TO: The Planning Board
FROM: Jeremy Doxsee, Town Planner
DATE: December 9, 2014
RE: Sketch Plan Review of C.N. Brown Convenience Store and Gas Station

STAFF REVIEW COMMITTEE NOTES

Case # 14-022 C.N. Brown Convenience Stores and Gas Station : The Committee will review and provide a recommendation to the Planning Board regarding a Sketch Plan Major Development Review application submitted by C.N. Brown, for development of a 5,100 sf convenience store, gas station, and Dunkin Donuts with a drive-thru, along with associated site improvements, on the 2.67 acre property located at 146 Bath Road, in the BNAS Reuse District & R-CMU Land Use District. Assessor's Map 40, Lot 40.

RE: **C.N. Brown Co.**
Proposed Convenience Store
146 Bath Road - Lot 5 – Brunswick Landing
Sketch Plan Submission

SKETCH PLAN

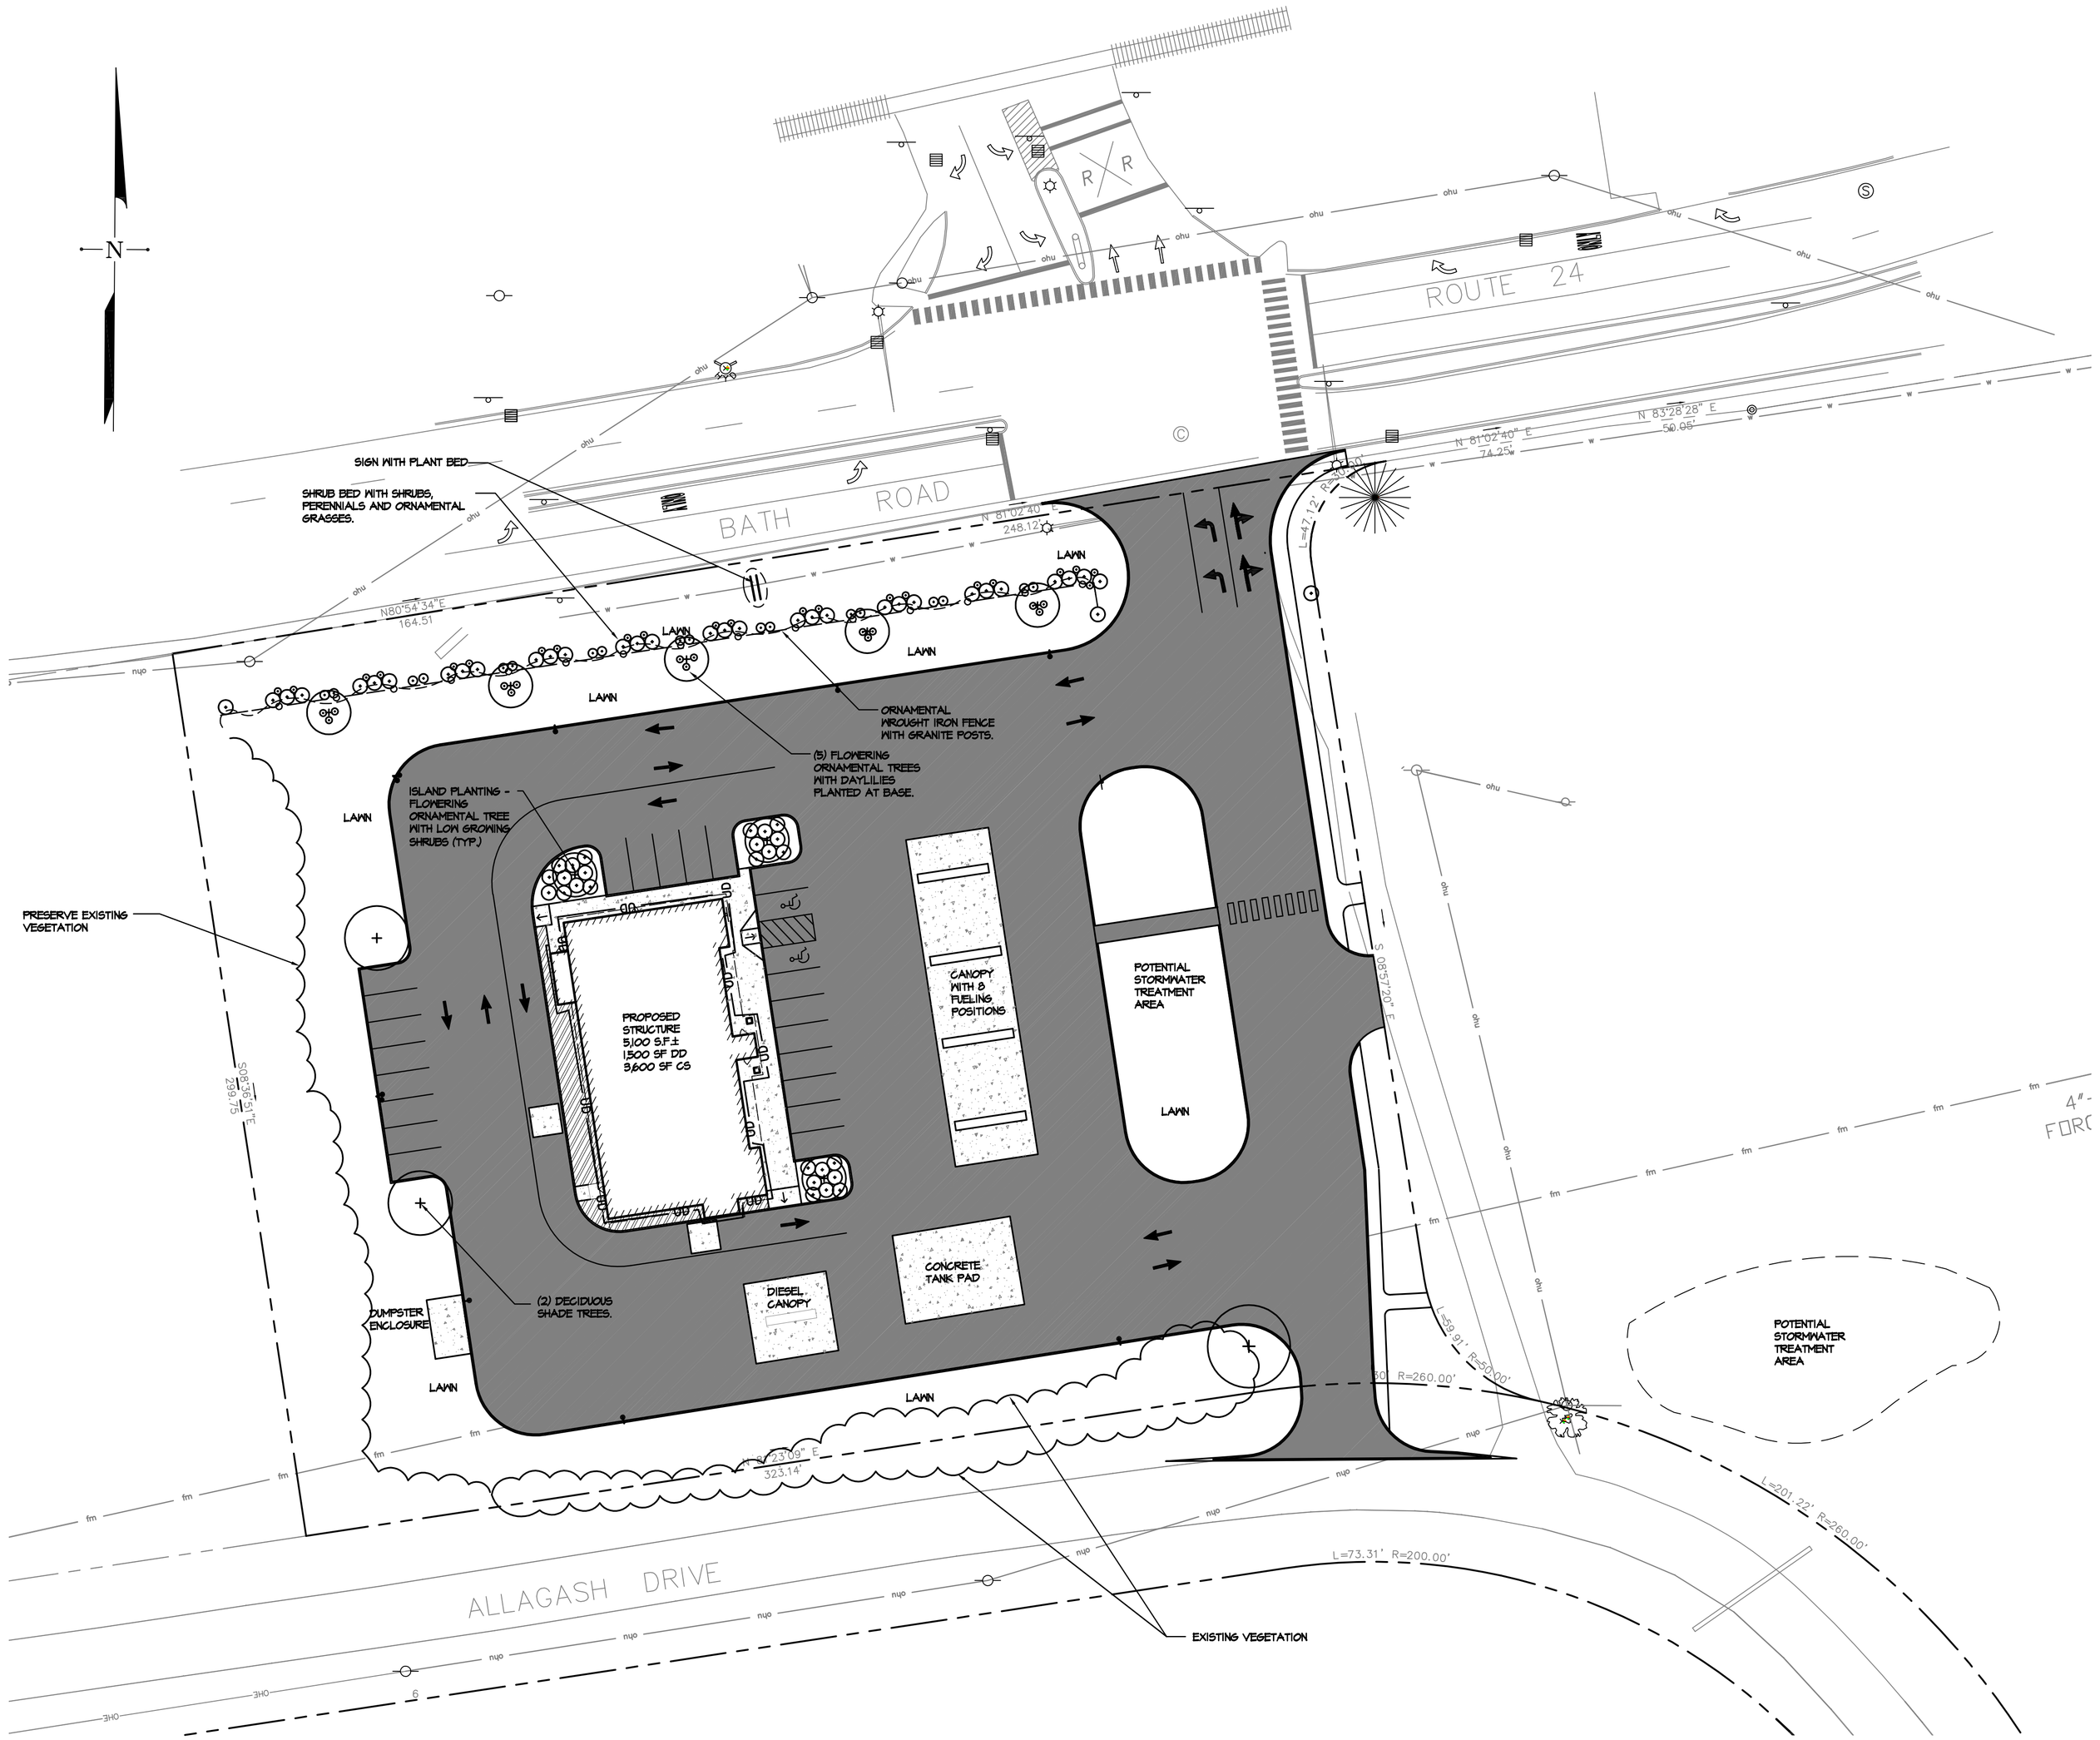
- The 50' curb cut leads into a parking lot that is wide open. Traffic isn't channelized – lots of room for conflict. The 50' opening is too wide for a 3 lane road.

- Concerns about ingress and egress. How will westbound traffic on Bath Road get into site? Eastbound traffic during rush hour at the light at Admiral Fitch often backs up into the Merry Meeting Plaza intersection. How will these issues be addressed?

- What is the purpose of the sidewalk that leads back to Allagash Road?

- Concern about parking lot access way leading from Bath Road to Allagash Road. What's preventing cars from using as a de facto thru-street? In Base Reuse Master Plan Allagash was envisioned to have minimal thru traffic and would serve as a key east-west bike route. Have you considered closing curb cut to Allagash?

- Anna asked about realigning curb cut to the west, to discourage pass-thru vehicles. Jim responded that location would create potential conflict with existing cars and cars using gas pumps.

- Jim: we can add mountable curbing in parking area to channel traffic, but still allow large delivery trucks maneuvering room. We will look at narrowing 50' curb cut as well.

- Tom indicated that, as a sketch submission, these details haven't been addressed yet. Traffic Engineer Bill Eaton will be working with Tom to adequately address. They submitted a Traffic Movement Permit to the DOT and these issues will be addressed as part of review.

- Jim: Agreed. Allagash has no sidewalk, so it's essentially a sidewalk to nowhere. We will eliminate portion of sidewalk leading to Allagash, but preserve sidewalk from street to eastbound access into lot 6.

- Jim: that would force cars in Brunswick Landing that want to use C-Store to take Admiral Fitch out to Bath Road and around to C-Store, which is unnecessarily channeling more traffic into busy intersections.

- Tom: internal connectivity is a preferred design feature.
  - Jim: we can add a speed table to slow thru-traffic. Anna asked if adding "no thru traffic" signs would help. There was general consensus that adding more signs probably wouldn't discourage cars intend on passing thru.
